# PLATEAU MINING COMPANY

May 2, 1986

Re: Waste Water Disposal System

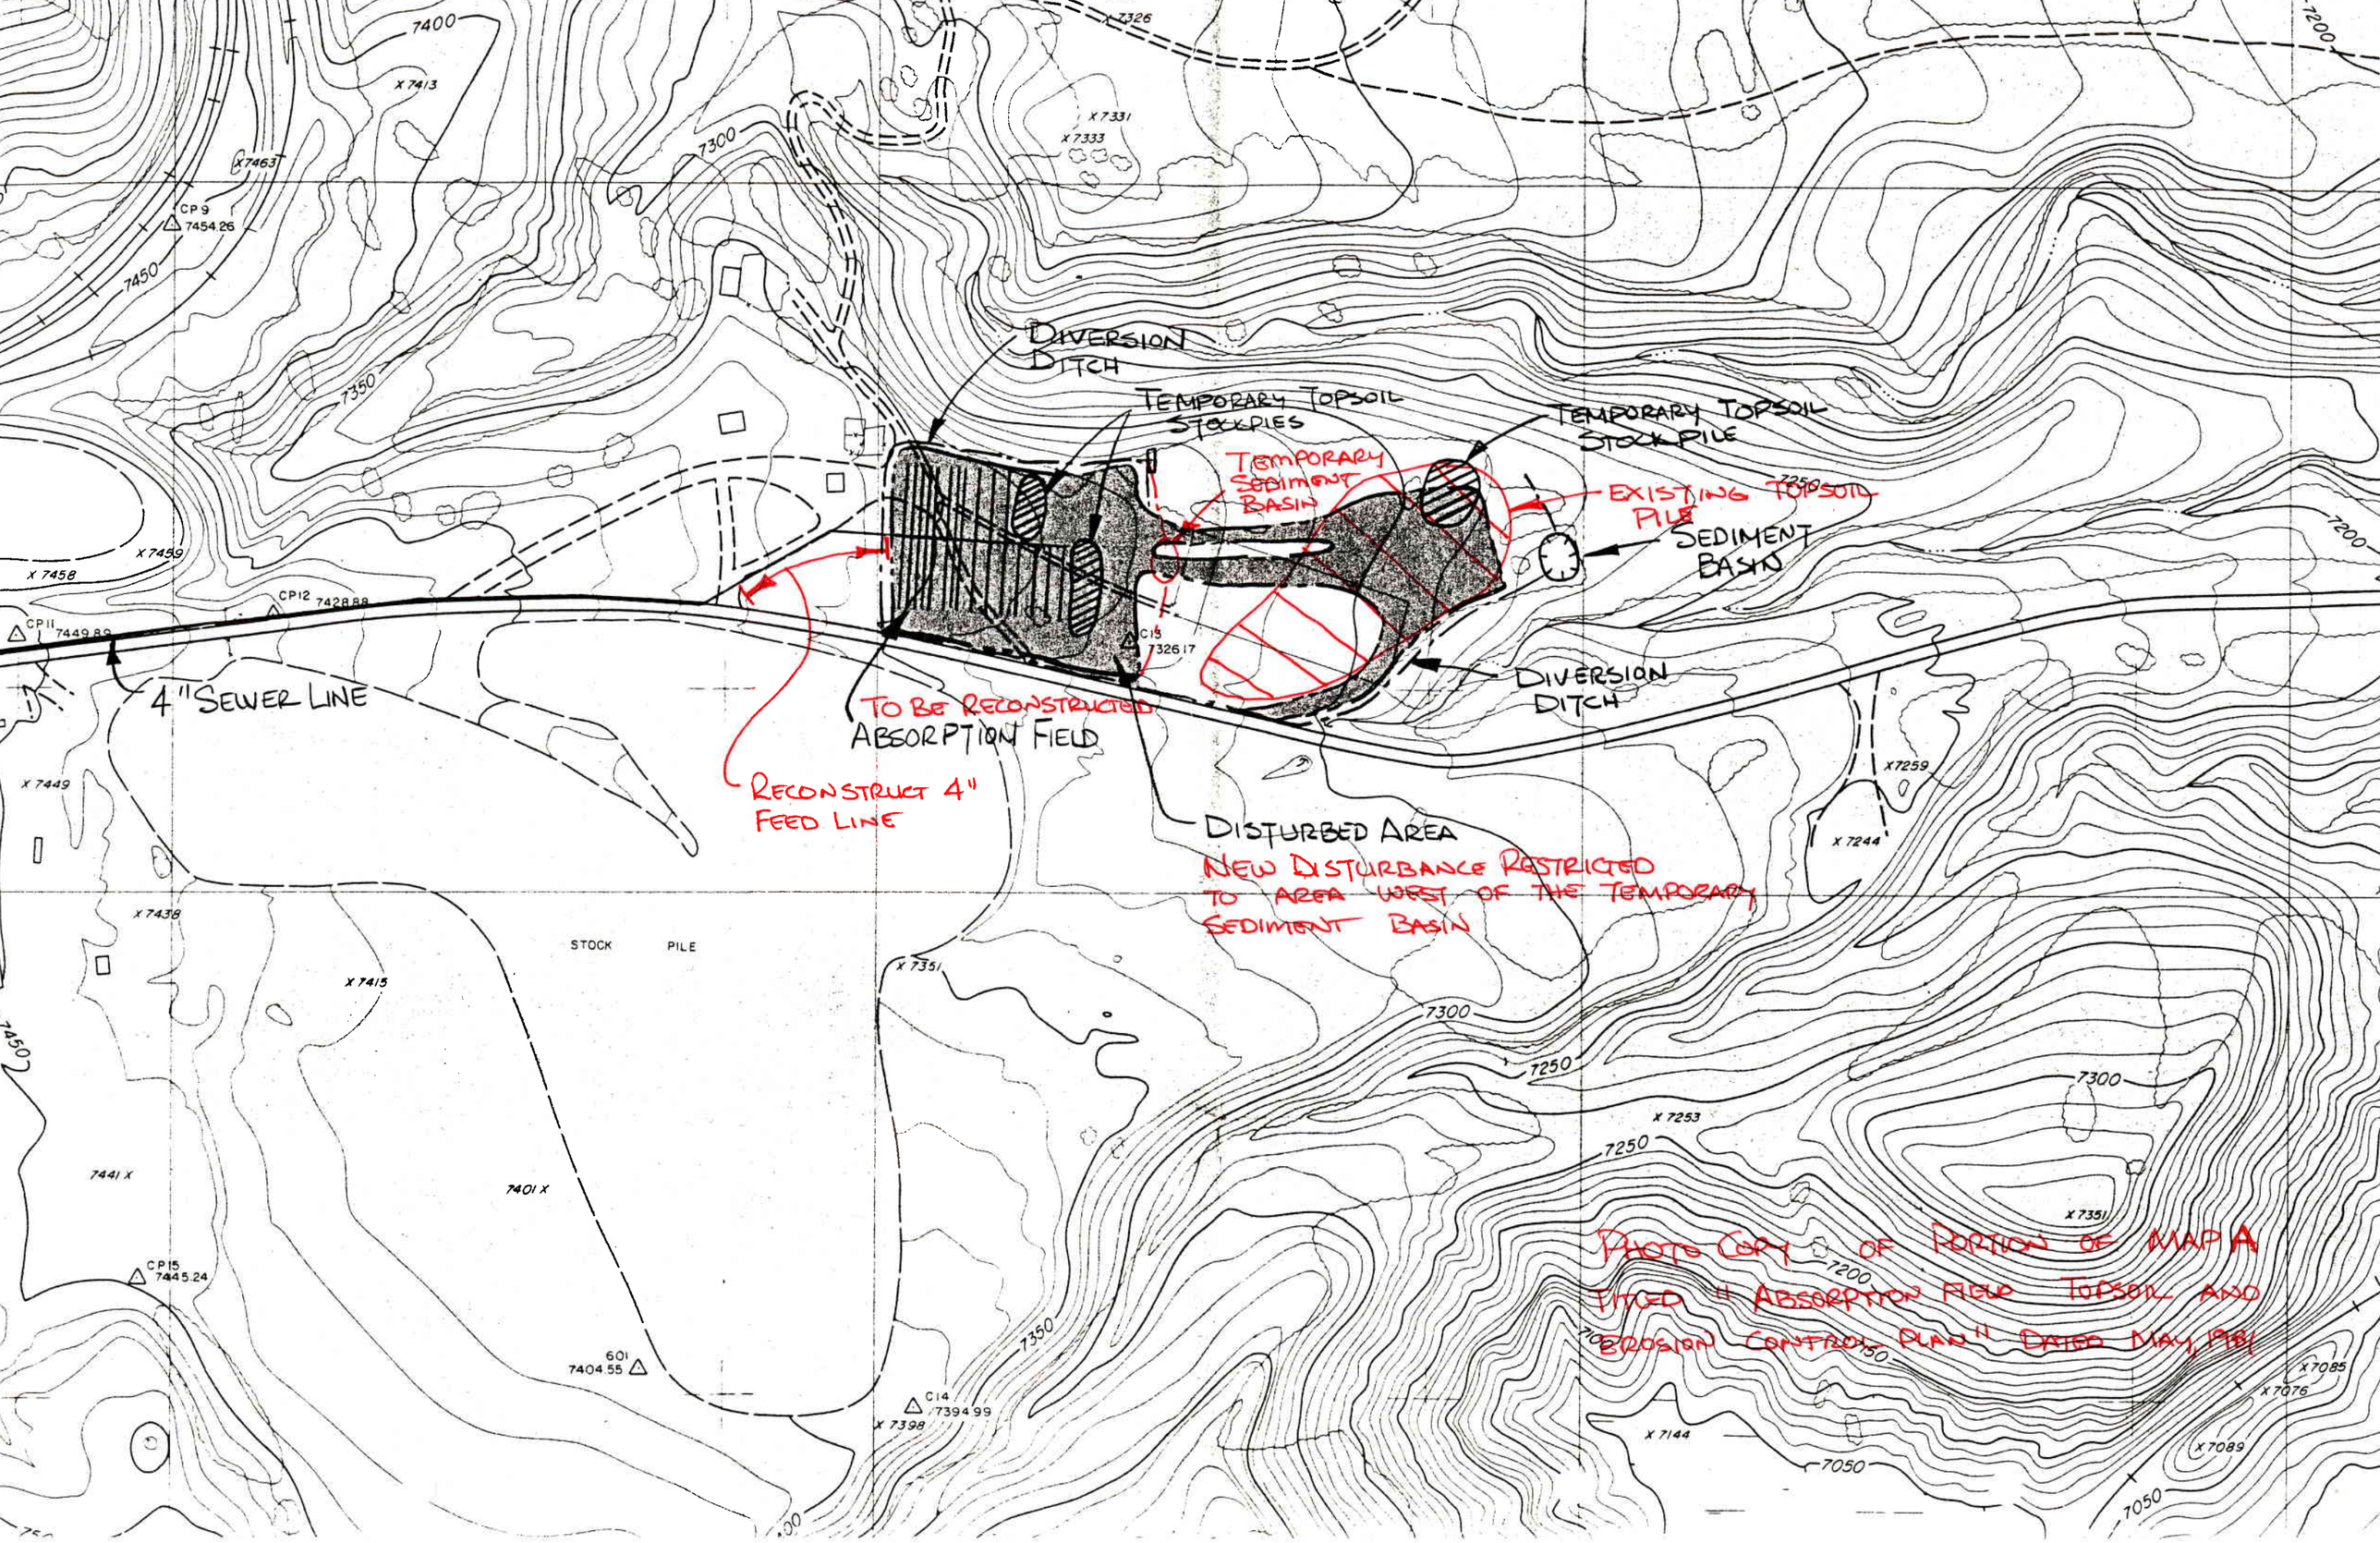
The plan enclosed was submitted to terminate NOV 81-2-3-3. Construction of new piping will follow the original plan as outlined with one exception; as shown on the enclosed map, the 4" sewer line feeding the absorption field must also be reconstructed for approximately 240 feet. This pipe is also plugged and is impossible to clean out.

Sediment control will consist of drainage ditches around the perimeter of the absorption field running to a temporary sediment basin at the lower end to collect any topsoil lost during construction and stabilization.

When construction is completed, topsoil will be redistributed and the area will be reseeded and mulched with a tackifier to help prevent soil loss from erosion and wind.
